SUBJECT: ISSUANCE OF AMENDMENT (TAC NO. 67743)

OYSTER CREEK NUCLEAR GENERATING STATION

AMENDMENT TO PROVISIONAL OPERATING LICENSE

Amendment No.129  
License No. DPR-16

FIGURE 3.10-4

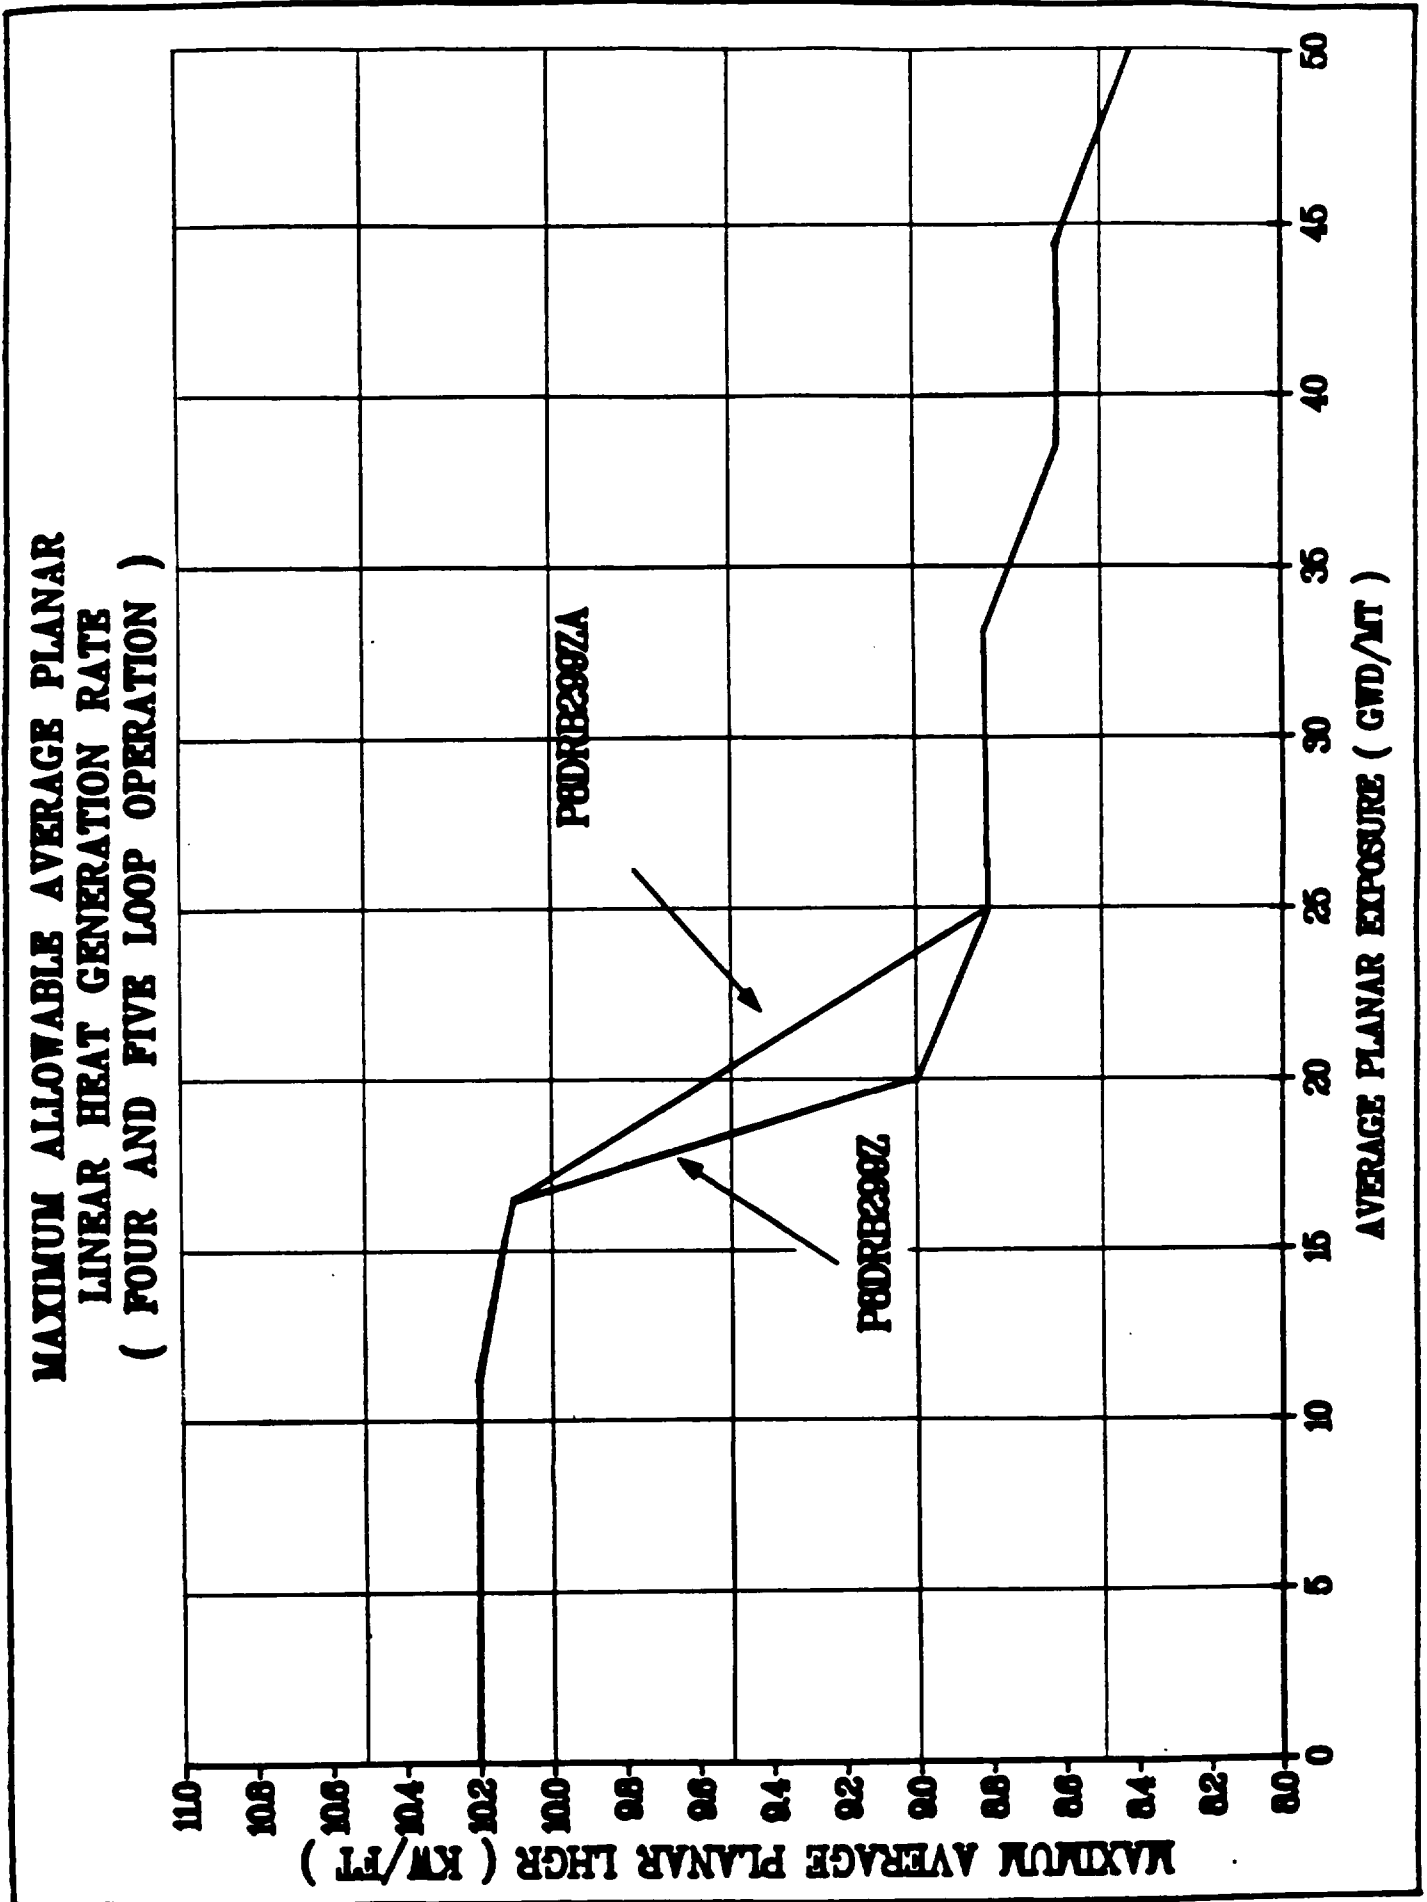
The maximum average planar LHGR (MAPLHGR) limit shown in Figure 3.10-4 and 3.10-5 for both 5-loop and 4-loop operation.

The maximum average planar LHGR limits of fuel types P8x8R and GE8x8EB are shown in Figure 3.10-4 and Figure 3.10-5, for both 5-loop and 4-loop operation, and are based on calculations employing the models described in Reference 4. Power operation with LHGR's at or below those shown in Figures 3.10-4 and 3.10-5 assures that the peak cladding temperature following a postulated loss-of-coolant accident will not exceed the 2200°F limit.

1. Section 3.10.A: Add new limits for GE8x8EB fuel and revise limits for P8x8R fuel design. The new and revised MAPLHGR will be applied to both four loop (with the inactive loop suction and discharged valves unisolated) and five loop operation.
2. Section 3.10.B: Add reference for new fuel design (GE8x8EB) to include LHGR limit of equal to or less than 13.4 kw/ft.
3. Section 3.10.C: Change operating limits MCPR from 1.45 to 1.51 for each of the three APRM status levels.
